Our Ref.: AA598/PD/H/R/004

6 February 2026

**Proposed Redevelopment for Hotel Use at Nos. 20-24 Tai Yau Street, San Po Kong, Kowloon and
Minor Relaxation of Non-Building Area for the
"Other Specified Uses" Annotated "Business Zone" of Section 16 Planning Application for
Approved Tsz Wan Shan, Diamond Hill and San Po Kong Outline Zoning Plan No. S/K11/31
Application No. A/K11/249 – Response to Departmental and Public Comments**

Appendix 1 – Figure T-1 Turntable Proposal

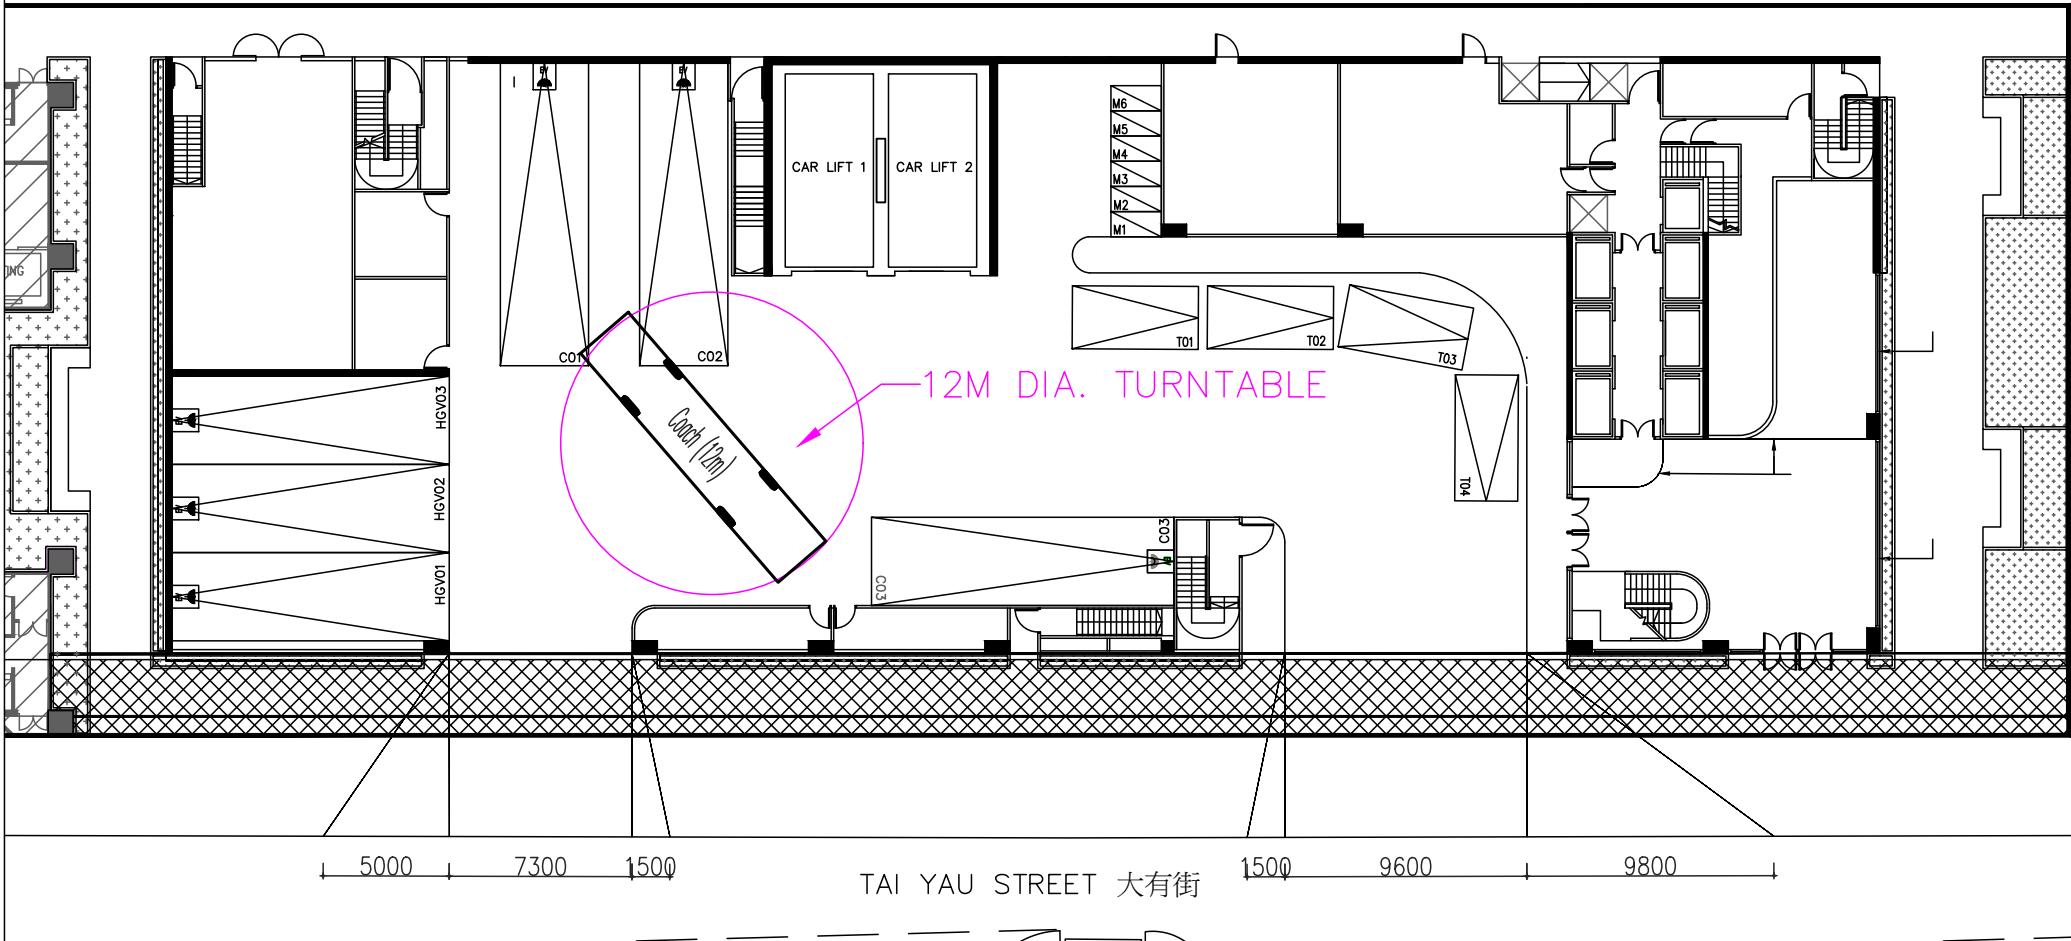
4. Commissioner for Transport	
<u>General Comment</u>	We previously explored the use of a turntable to facilitate parking for heavy goods vehicles and coaches. Unfortunately, due to the limited space within the subject site, the turntable could not be effectively utilized. In particular, when a coach is positioned over the turntable, the system becomes inoperable. As a result, we have decided not to adopt the turntable option. (Please refer to the attachment Appendix 1 - FIGURE T-1). The swept path analysis we provided has already minimized the number of turning movements required within the subject site. In addition, experienced traffic controllers will be deployed to assist with vehicle parking and manoeuvring when entering and exiting the subject site.
<p>a) The swept path analysis indicates that the maneuvering path for long vehicles is very tight and it requires moving forward/ backward multiple times for parking and leaving the site. Please review the parking layout.</p> <p>b) Please indicate the headroom for ground floor and basement B1 floor in the architectural drawings.</p> <p><u>Road widening works at Tai Yau Street</u></p> <p>d) The proposed 3m-wide NBA from the lot boundary abutting Tai Yau Street ties in with the proposed traffic improvement works in San Po Kong requiring setbacks from public roads for future road widening and the air ventilation purpose. Since the road widening works are subject to the setback of other sites along Tai Yau Street, no road widening work is under planning for the time being.</p>	Noted. The architectural drawings have been updated to clearly indicate the clear headroom of ground floor and basement B1. Please refer to the attachment - the ground floor plan in drawing no. GBP-02 (Rev.B) and basement floor plan in drawing no. GBP-01 (Rev.B).
